Bid 638
New HVAC Modernization Project for Oxnard High School

BID CLARIFICATION ADDENDUM #1

Dated: November 01, 2020

Bid Clarification Addendum #1
Attachment A
Signet Controls RFI

DRAWING NUMBER: **AE4.1**

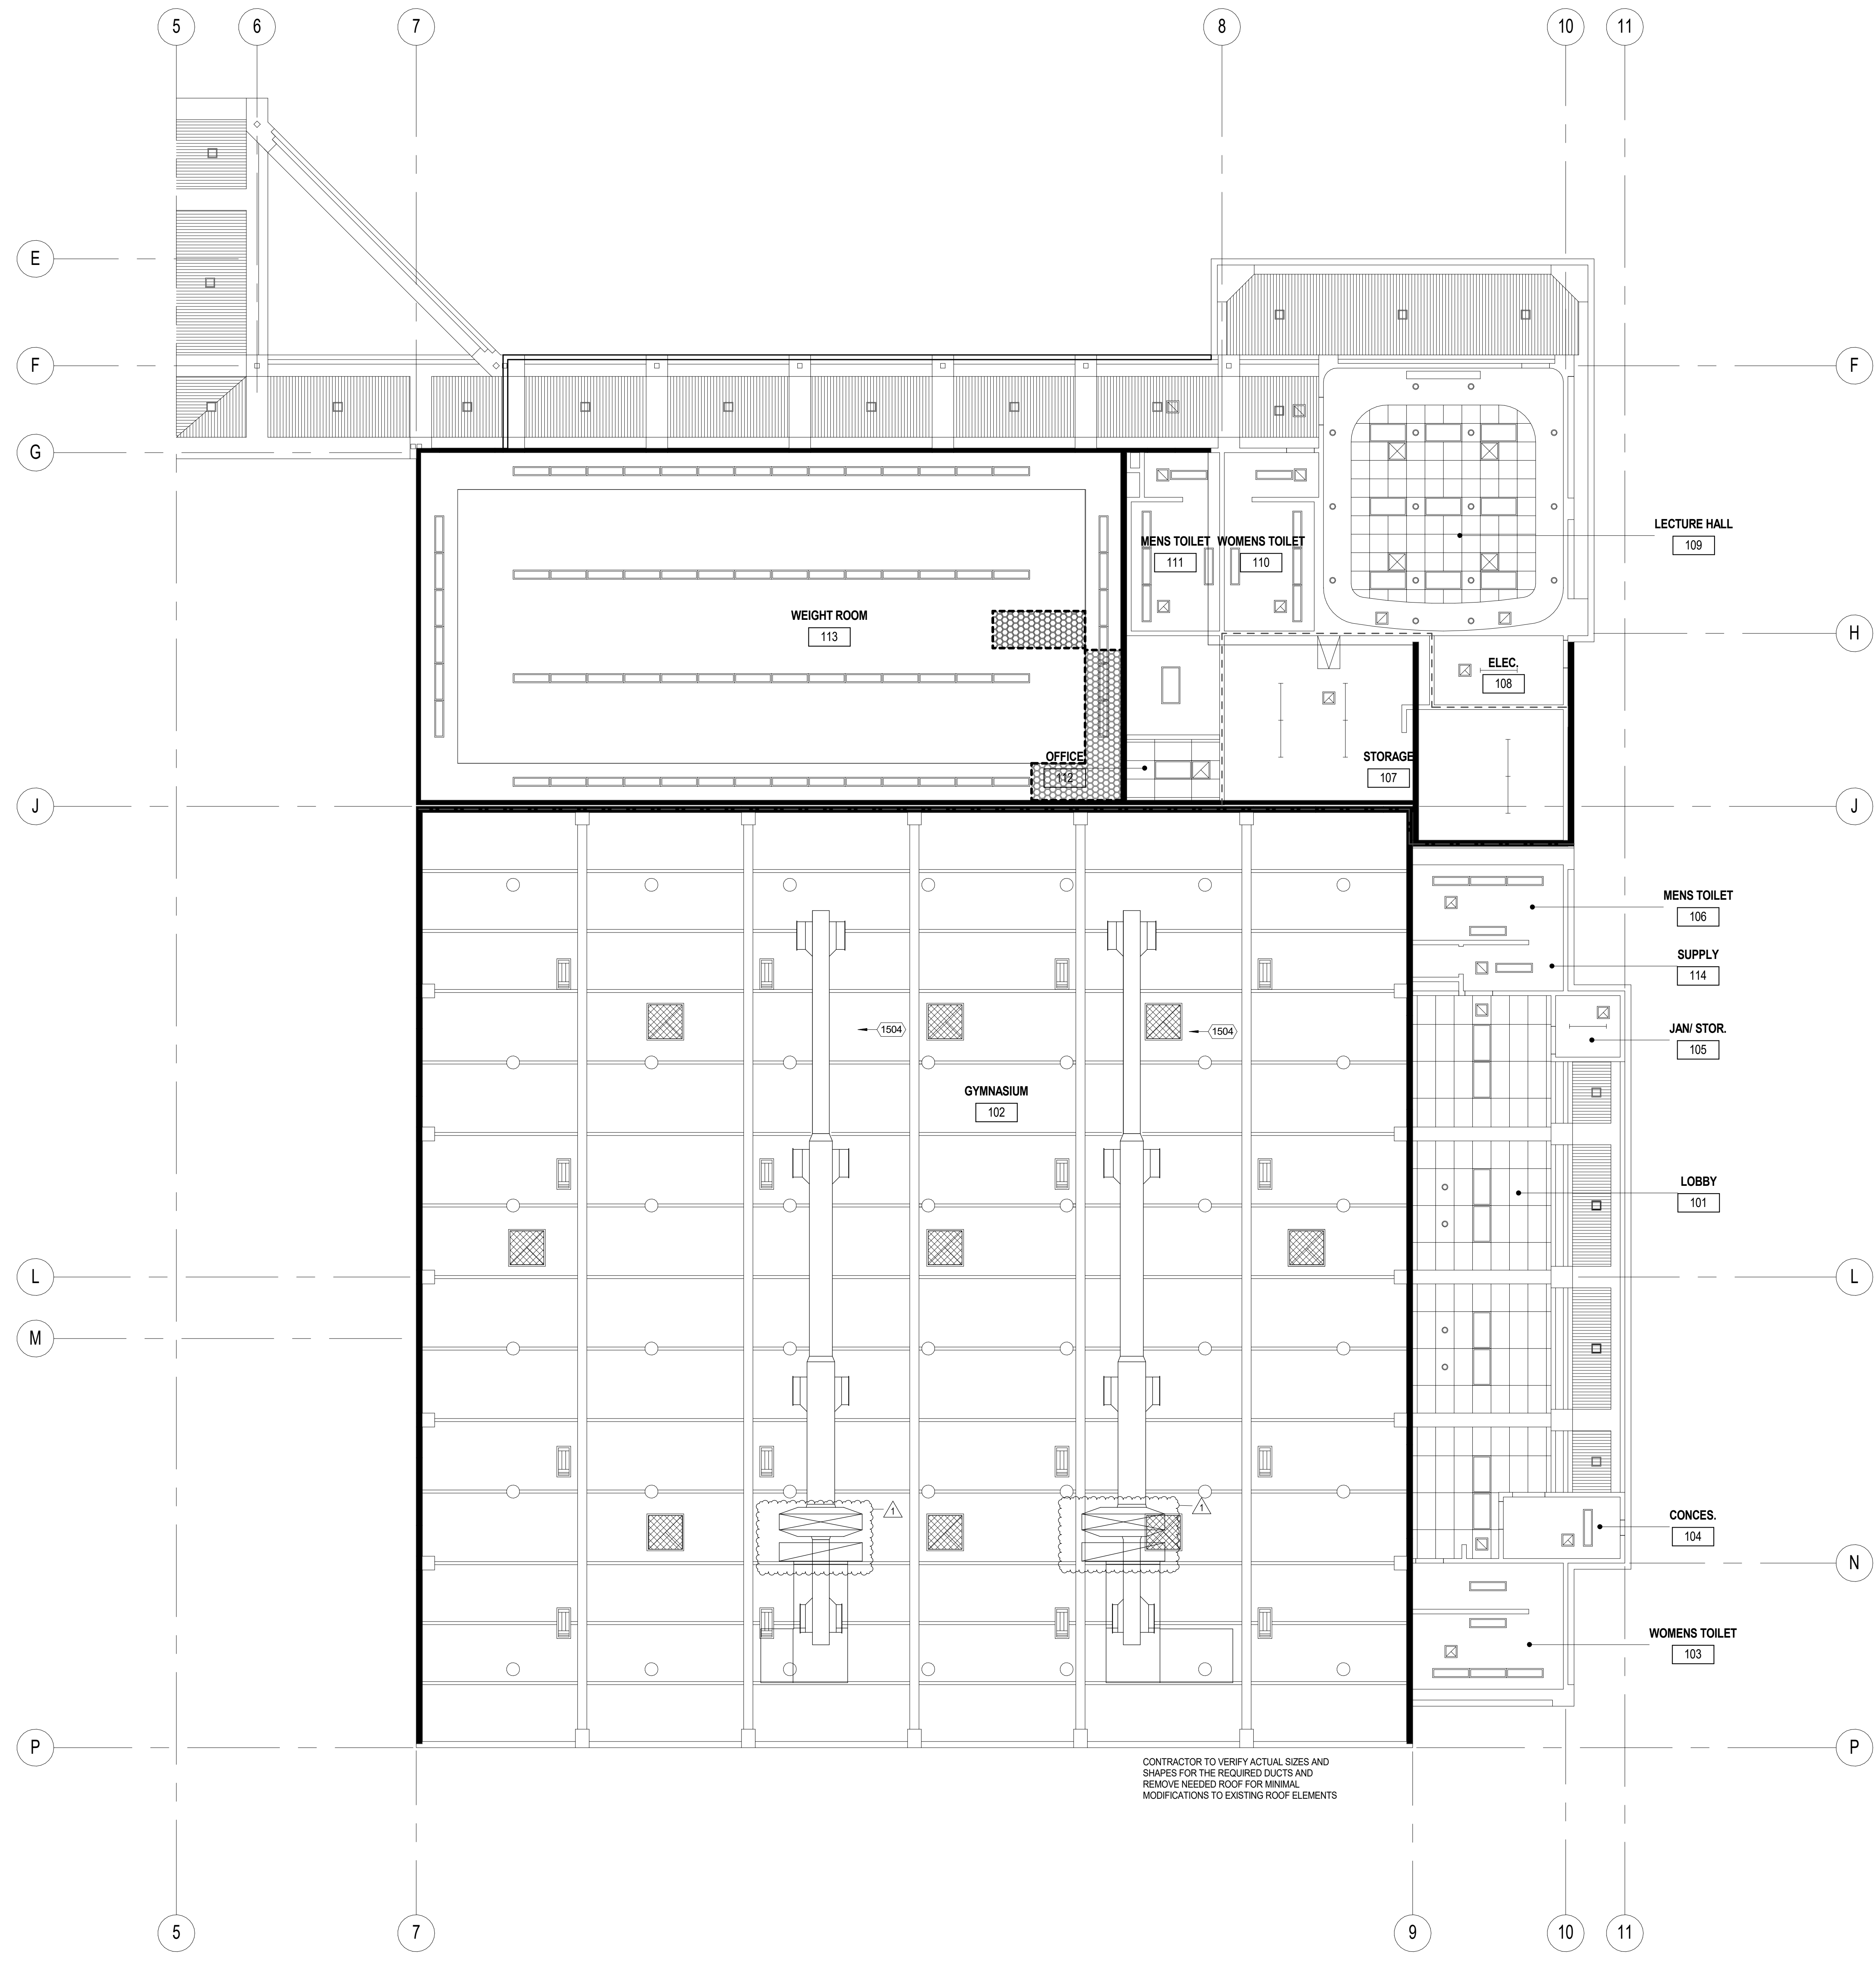
- A. Replace DSA approved Drawing AE4.1 in its entirety with the attached revised Drawing AE4.1 (Revised hatch pattern and Legend to leave metal decking in place. Revised "13/S0.3" to "14/S0.3" in Legend. Revised 12/7.1 to 6/7.1 in Legend).

DRAWING NUMBER: **AG3.1**

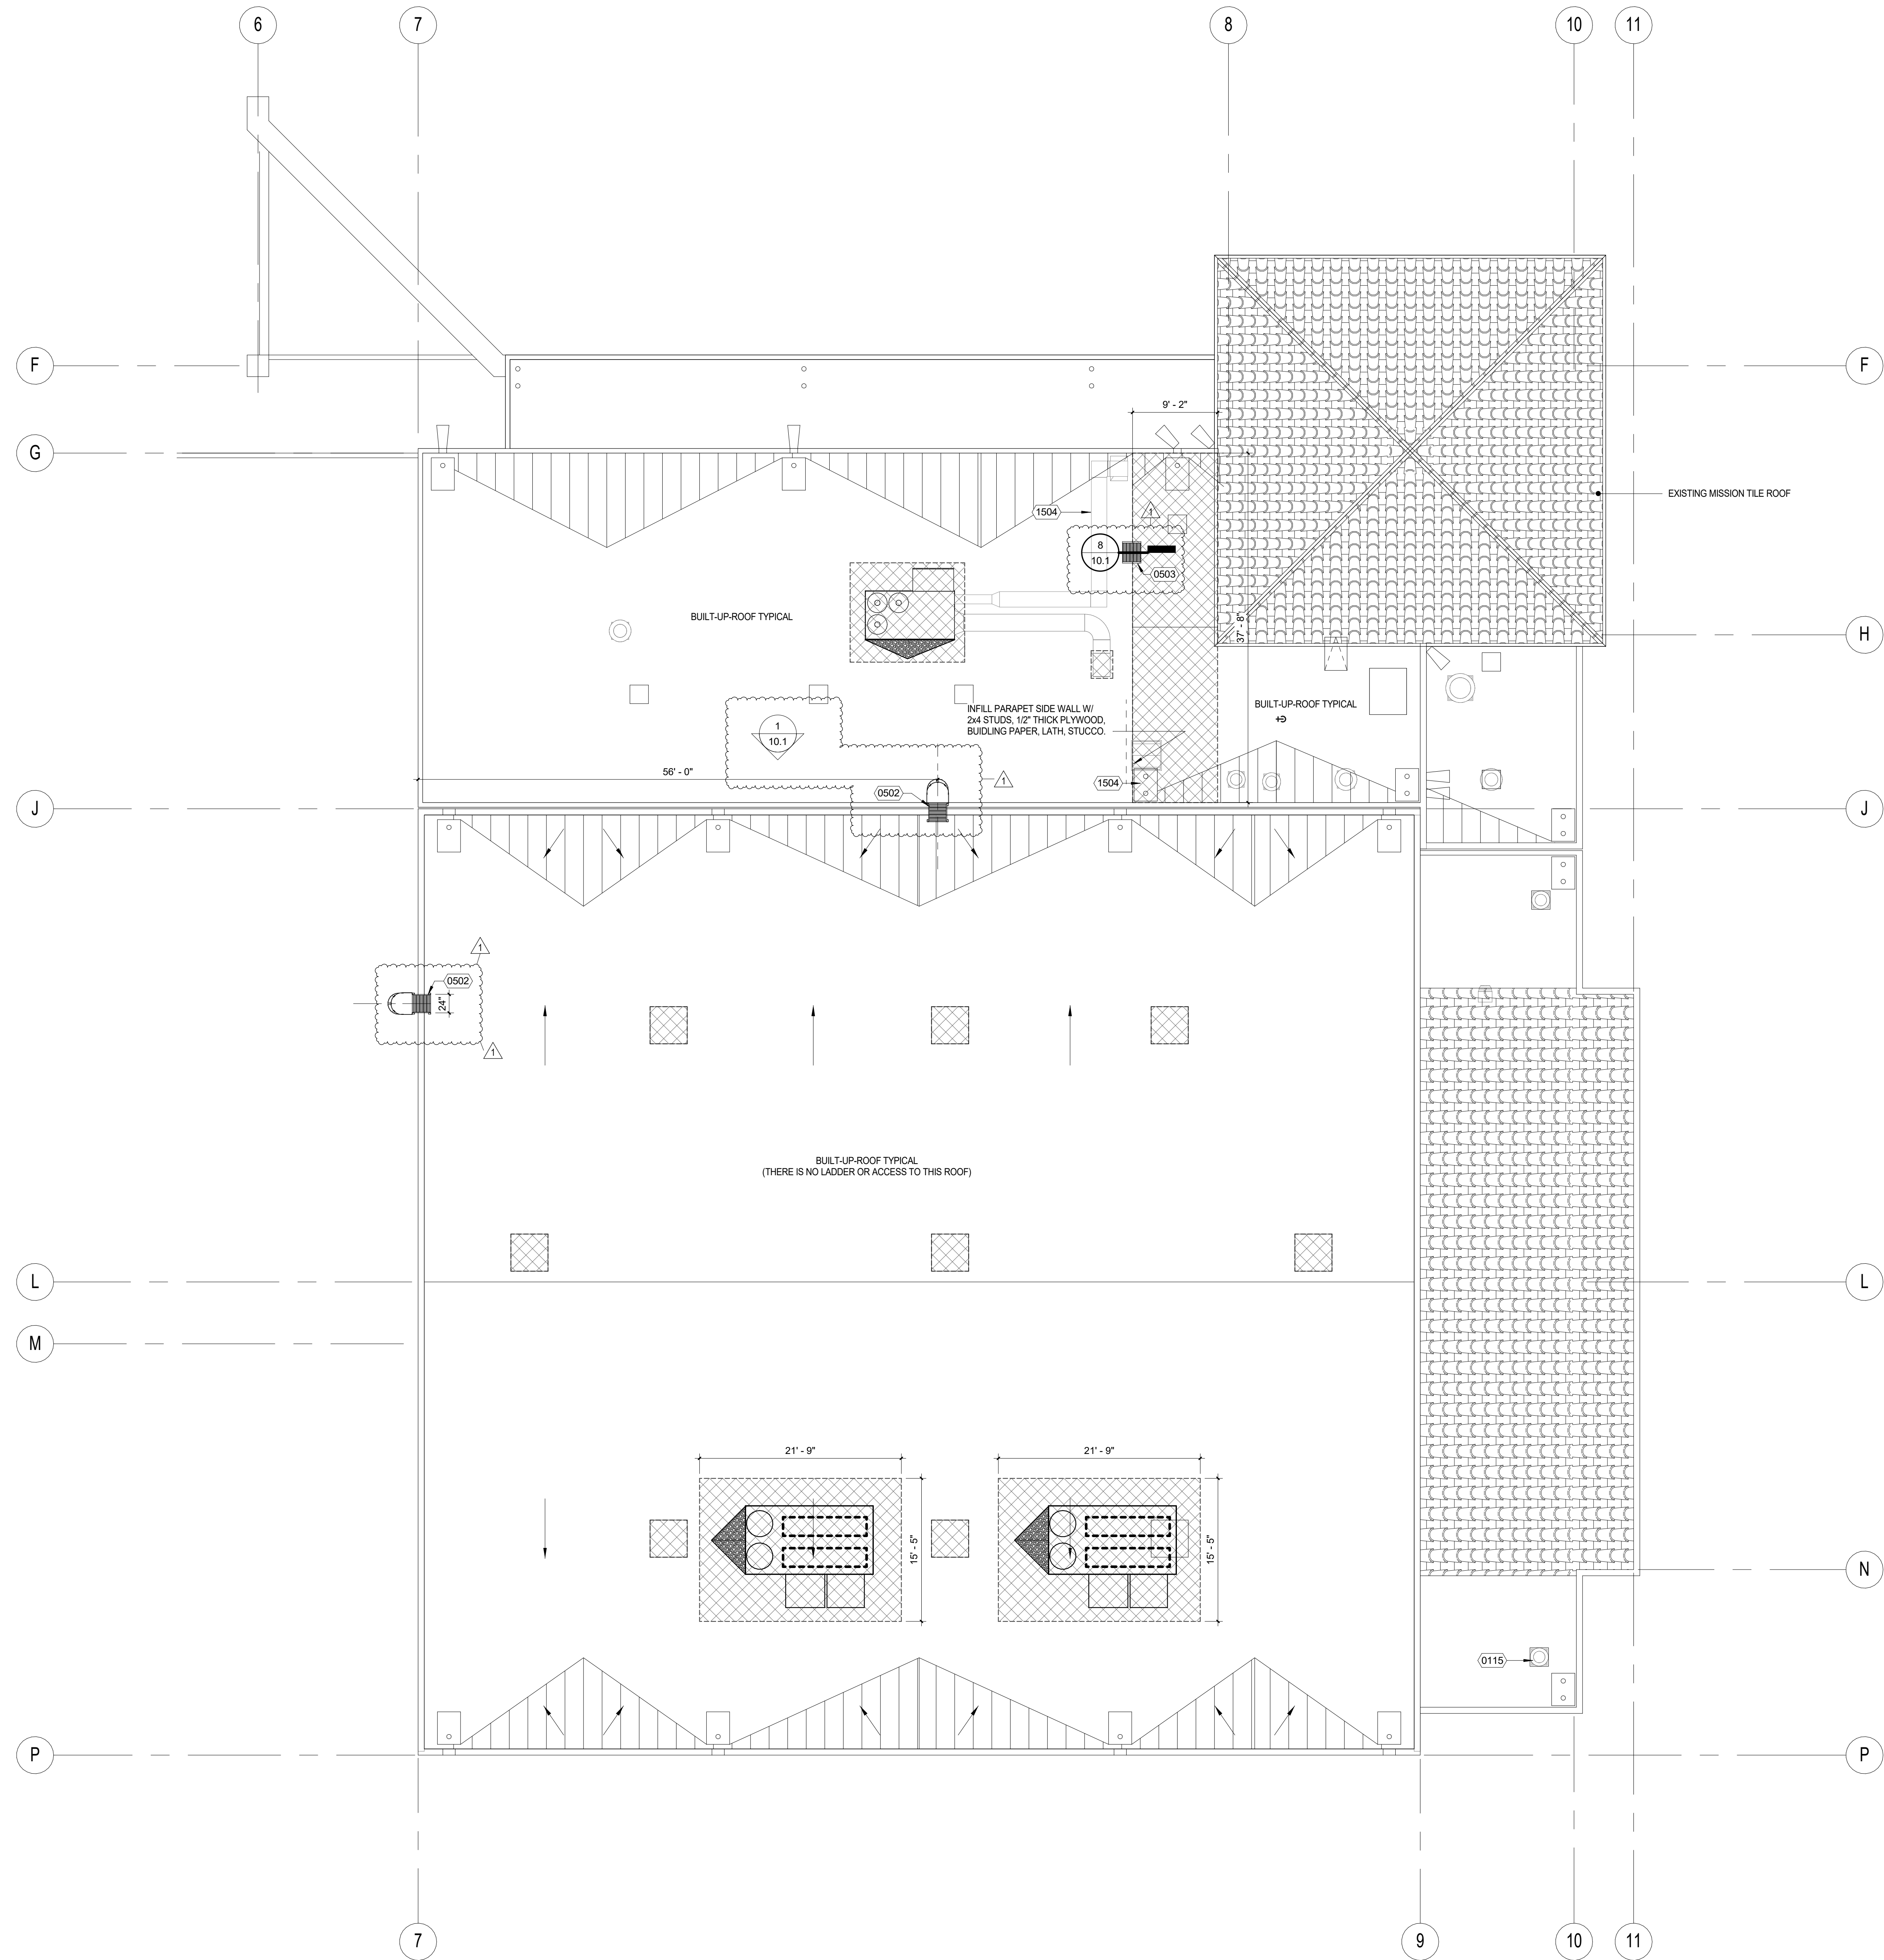
- A. Replace DSA approved Drawing AG3.1 in its entirety with the attached revised Drawing AG3.1 (Updated duct work to match mechanical drawing. Updated notes in Legend).

DRAWING NUMBER: **AJ4.1**

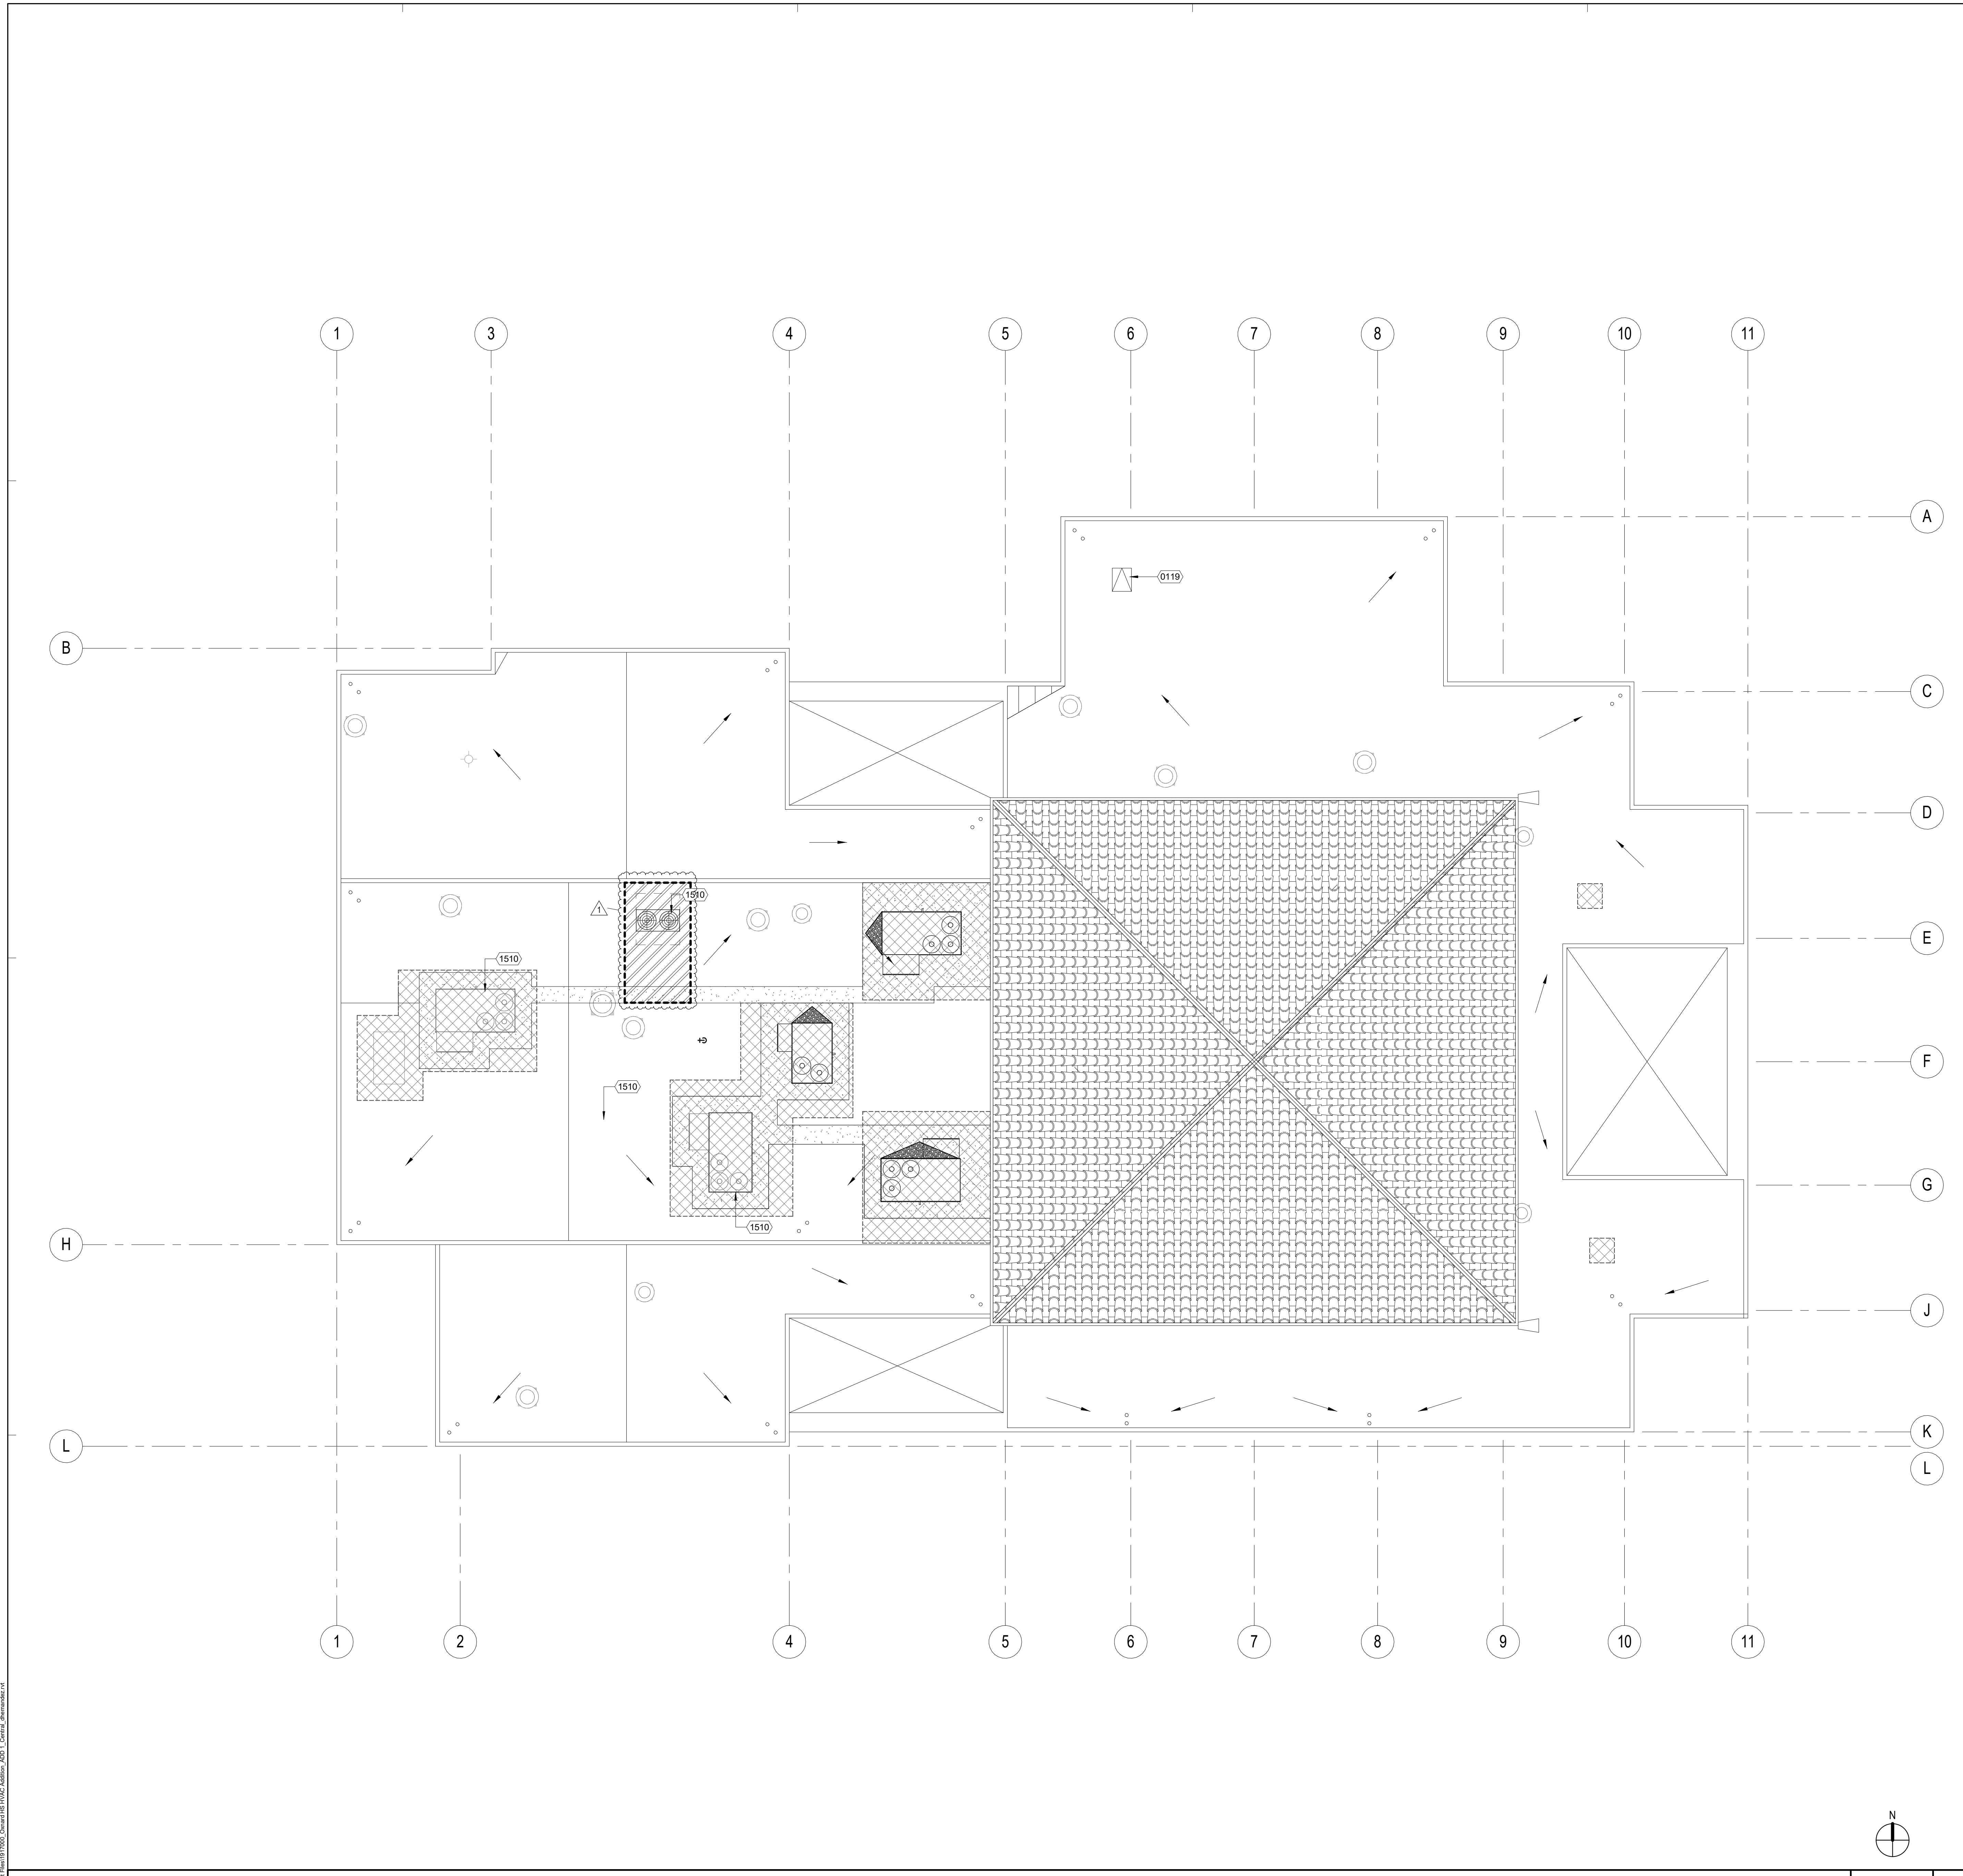
- A. Replace DSA approved Drawing AJ4.1 in its entirety with the attached revised Drawing AJ4.1 (Revise "12/7.1" to "6/7.1" and "13/S0.3" to "14/S0.3". Revised roof hatch pattern, add new hatch pattern and new patch back description to legend).
